Proposal for Draft global technical regulation on electric vehicle safety

Proposal of amendments to ECE/TRANS/WP.29/GRSP/2017/02

The modifications to the current text of ECE/TRANS/WP.29/GRSP/2017/02 are marked in bold or strikethrough characters.

"Figure 22

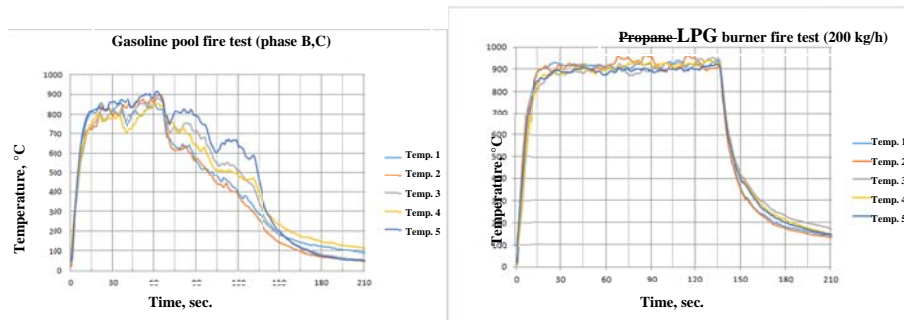
Figure 22, modify the entire figure:

Test scene photographs and temperature measurements of a gasoline pool fire and an LPG burner fire

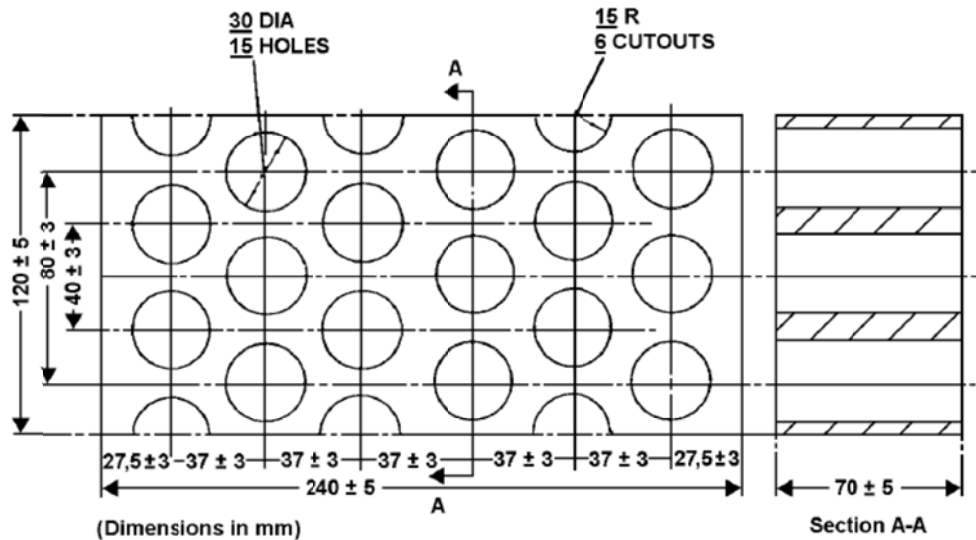
Figure 13 (paragraph 6.2.4.3.3.4.4.) and Figure 28 (paragraph 8.2.4.3.3.4.4.), modify the figures to include "A-A":

Figure 16
Schematics of how to measure wrap-around distance

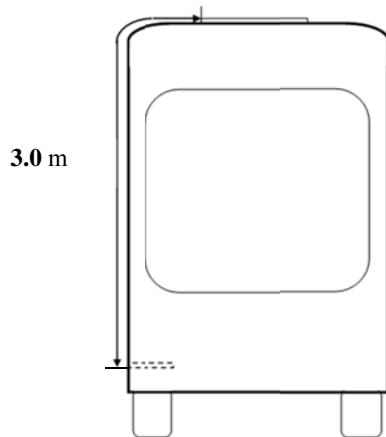
High voltage live parts shall comply with paragraphs 7.1.1.1.1. and 7.1.1.1.2. for protection against direct contact. Conductive connection devices not energized except during charging of the REESS are exempted from this requirement if located on the roof of the vehicle, out of reach for a person standing outside of the vehicle ~~or standing on the instep of the of the vehicle.~~ **For Category 1-2 vehicles the minimum wrap around distance from the instep of the vehicle to the roof mounted charging devices is 3.00 m. In case of multiple steps due to elevated floor inside the vehicle, the wrap around distance is measured from the bottom most step at entry, as illustrated in Figure 16. ~~(the minimum wrap around distance from the instep 3.75 m, as illustrated in Figure 16) or underneath the vehicle, and not directly accessible by a person standing on the side of the vehicle.~~**

"Figure 2

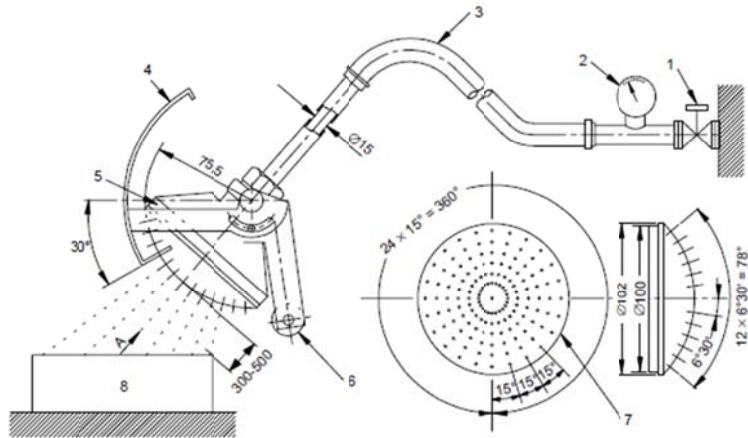
Figure 2, modify the entire figure including the notes:

Splashing test nozzle
